AGENDA
BOARD OF ZONING APPEALS
WEDNESDAY, July 15, 2026
6:30 P.M.

STAFF REPORT

Applicant	Veite Design, c/o Nicholas Veite
Location	222 N Elm Street
Owner	Redhawks on Elm, LLC, c/o Javier Zuluaga
Action Request	Variances to <i>Section 1143.03(c)</i> minimum front yard setback and <i>Section 1143.03(d)(5)(B)</i> minimum roof pitch
Lot Size	5,056 square feet
Lot Width	58.5 feet
Current Use	Single-unit dwelling (used as a Lodging House for 6 total occupants)
Current Zoning	R-1MS Single-Family Residential Mile-Square District
Surrounding Land Uses	Multi-Family Residential across N Elm Street to the east; Single-Family Residential in all other directions

RE: **Variance #BZA-2026-01 | 222 N. Elm St.**

ELEVATIONS

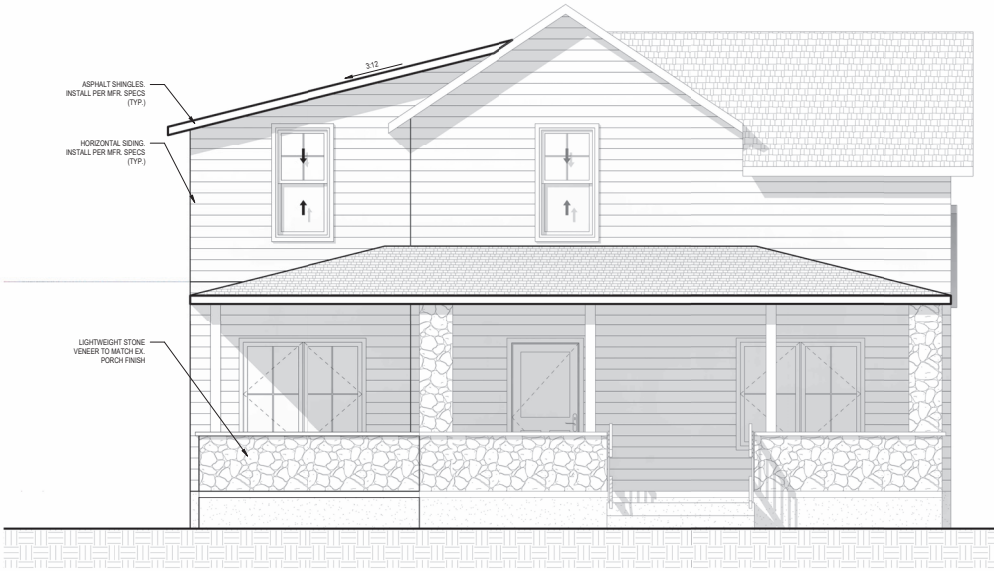
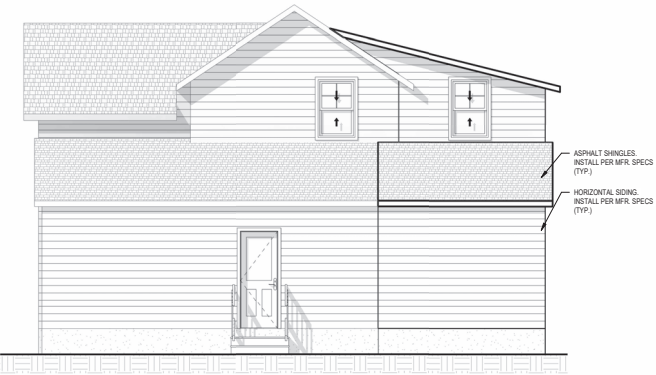
that should have a minimum pitch ratio of 4 to 12. The elevations on Sheet A.4 show that the addition would have a 3:12 sloped roof, which does not comply with the minimum 6:12 ratio. The existing 4:12 roof plane in the rear which is being extended also does not comply. Roofs must have a minimum 6:12 pitch unless a Variance is approved

2. **Section 1143.03(d)(5)(B)** provides that *roof pitches for residential structures must be steep. A minimum pitch ratio of 6 to 12 is required with the exception of porch roofs that should have a minimum pitch ratio of 4 to 12.* The elevations on Sheet A.4 show that the addition would have a 3:12 sloped roof, which does not comply with the minimum 6:12 ratio. The existing 4:12 roof plane in the rear which is being extended also does not comply. **Roofs must have a minimum 6:12 pitch unless a [Variance](#) is approved.**
